SUBJECT: DONALD C. COOK NUCLEAR PLANT, UNIT 1 - AMENDMENT NO. 167 TO FACILITY  
OPERATING LICENSE NO. DPR-58 (TAC NO. M71480 AND M75260)

AMENDMENT NO. 167 TO FACILITY OPERATING LICENSE NO. DPR-58-D. C. COOK

ATTACHMENT TO LICENSE AMENDMENT NO. 167  
TO FACILITY OPERATING LICENSE NO. DPR-58  
DOCKET NO. 50-315

SAFETY EVALUATION BY THE OFFICE OF NUCLEAR REACTOR REGULATION  
RELATED TO AMENDMENT NO. 167 TO FACILITY OPERATING LICENSE NO. DPR-58

FIGURE 3.4-2

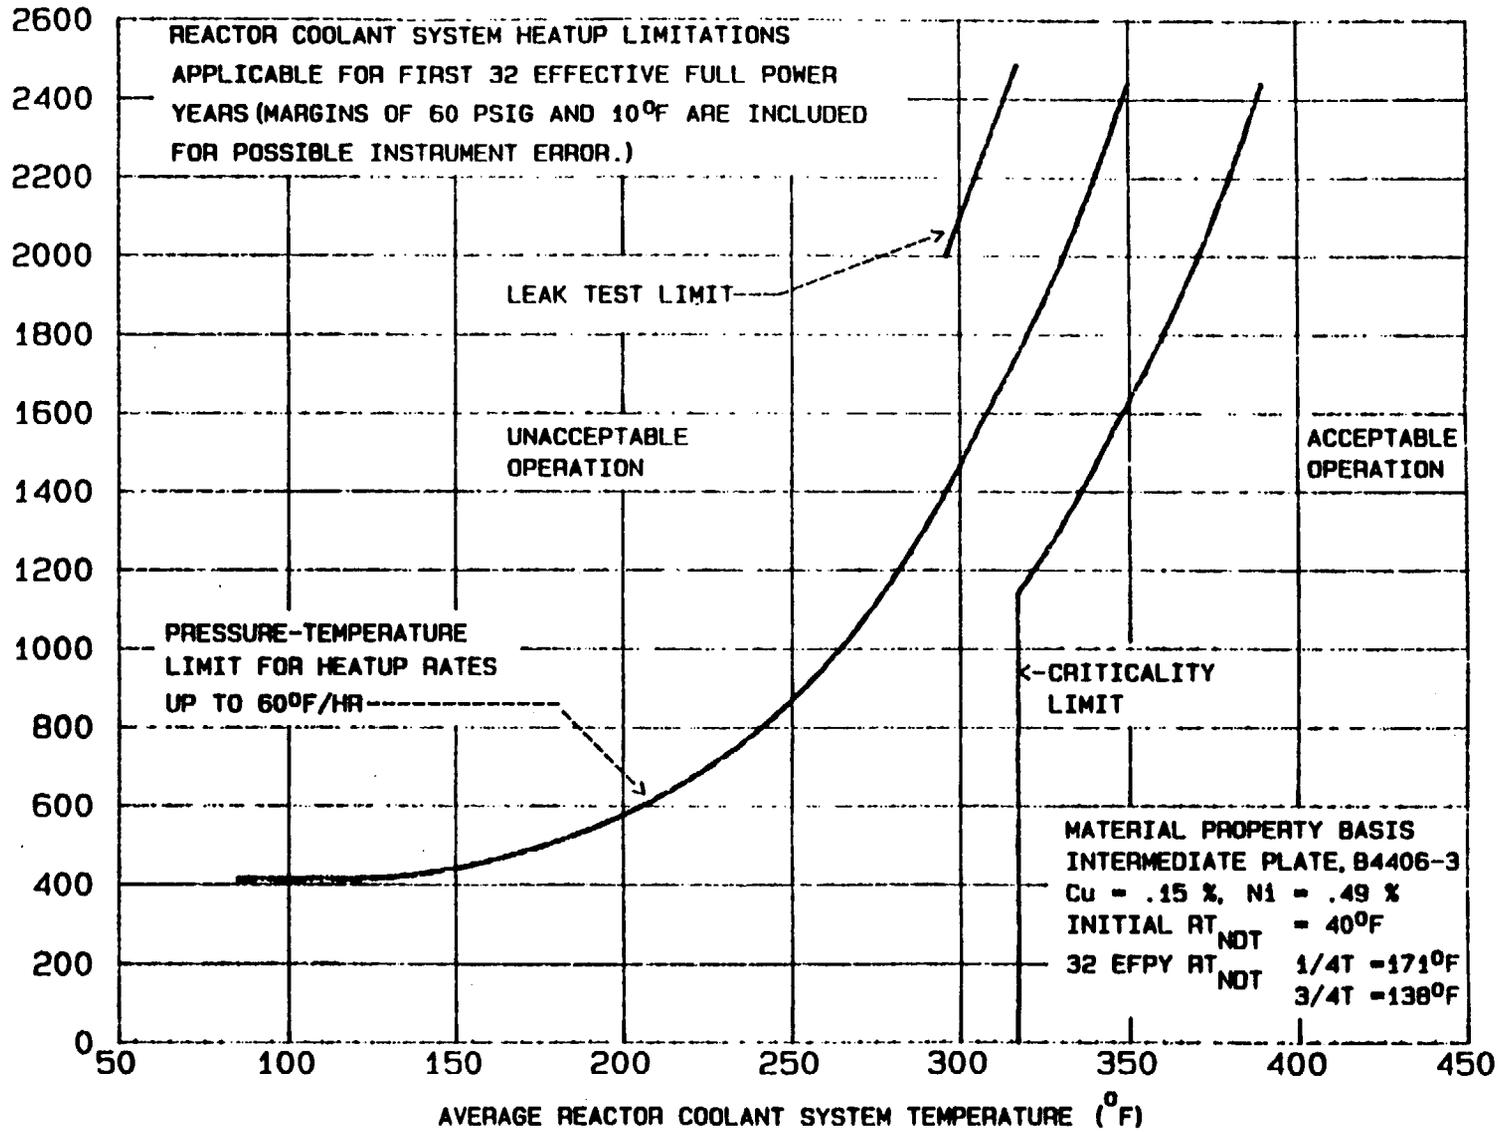
This amendment changes Technical Specifications (TS) concerning, "Pressure-Temperature Limits," to limit the maximum heat up rate to 60°F/hr and to provide revised heat up and cooldown pressure-temperature (P-T) limit curves. In addition, the amendment changes the TS to reflect revisions to the pressure set point and enable temperature for the low-temperature overpressure protection system. The revisions are based on a reanalysis of reactor vessel sample material in accordance with Regulatory Guide 1.99, Revision 2. Through this licensing action the guidance of Generic Letter 88-11 has been followed for D. C. Cook, Unit No. 1.

3.4.9.1 The Reactor Coolant System (except the pressurizer) temperature and pressure shall be limited in accordance with the limit lines shown on Figures 3.4-2 and 3.4-3 during heatup, cooldown, criticality, and inservice leak and hydrostatic testing with:

- a. A maximum heatup of 60°F in any one hour period,
- b. A maximum cooldown of 100°F in any one hour period, and
- c. A maximum temperature change of  $\leq 5^\circ\text{F}$  in any one hour period, during hydrostatic testing operations above system design pressure.

The heatup limit curve, Figure 3.4-2, is a composite curve which was prepared by determining the most conservative case, with either the inside or outside wall controlling, for any heatup rate up to 60°F per hour. The cooldown limit curves of Figure 3.4-3 are composite curves which were prepared based upon the same type analysis with the exception that the controlling location is always the inside wall where the cooldown thermal gradients tend to produce tensile stresses while producing compressive stresses at the outside wall. The heatup and cooldown curves were prepared based upon the most limiting value of the predicted adjusted reference temperature at the end of 32 EFPY.

The pressure-temperature limit lines shown on Figure 3.4-2 for reactor criticality and for inservice leak and hydrostatic testing have been provided to assure compliance with the minimum temperature requirements of Appendix G to 10 CFR 50.

The licensee used the method in RG 1.99, Rev. 2, to calculate an ART of 171°F at 1/4T and 138°F at 3/4T at 32 EFPY for the same limiting plate. The staff judges that a difference of 9.7°F between the licensee's ART at 1/4T of 171°F and the staff's ART of 161.3°F is acceptable because the licensee has used a more conservative Chemistry Factor (CF-6) which was presented without explanation in the Capsule U report. Substituting these ARTs into equations in SRP 5.3.2, the staff verified that the proposed P/T limits for heatup, cooldown, and hydrotest meet the beltline material requirements in Appendix G of 10 CFR Part 50.

The staff concludes that the proposed P-T limits for the reactor coolant system for heatup, cooldown, leak test, and criticality are valid through 32 EFPY because the limits conform to the requirements of Appendices G and H of 10 CFR Part 50. The P-T limits also satisfy Generic Letter 88-11 because the licensee used the method in RG 1.99, Rev. 2 to calculate the ART. Hence, the proposed P-T limits may be incorporated in the DCCNP, Unit 1 Technical Specifications.
